Access Compliance Report

Public Rights-of-Way

| Intersection ID: 31839 | Main Street: RUGGED_STONE_WY | Cross Street: SILVER_FALLS_WY | Location: SW |
| ADA ID: CD3029841CB8 | Ramp Type: PerpDiag | Initial Pass/Fail: Fail | Overall Compliance: No |

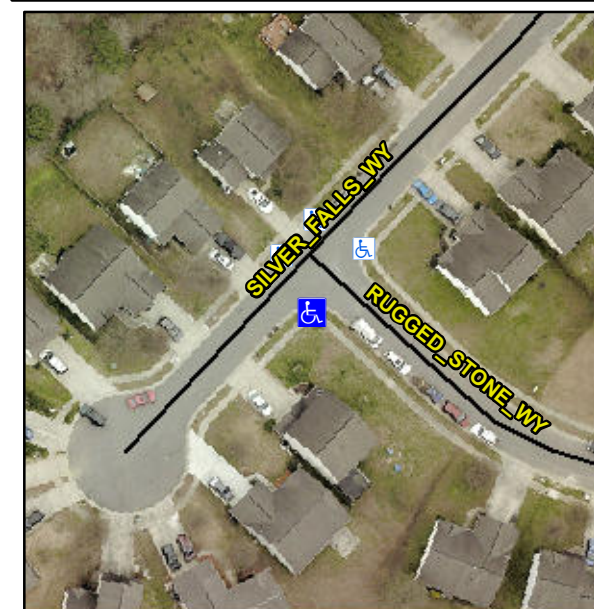
Not Found, R304.5.1, R304.2.2, R304.5.3

| Compliance | Description | Data | Compliance | Description | Data |
|------------|-----------------------|-------|------------|-----------------------------|-------|
| N/A | Ramp Length (in) | 47.0 | No | Ramp Slope (%) | 11.4 |
| No | Ramp Width (in) | 45.0 | No | Ramp XSlope (%) | 6.8 |

Remove & Replace Curb Ramp With Two New Directional Ramps or Equivalent.
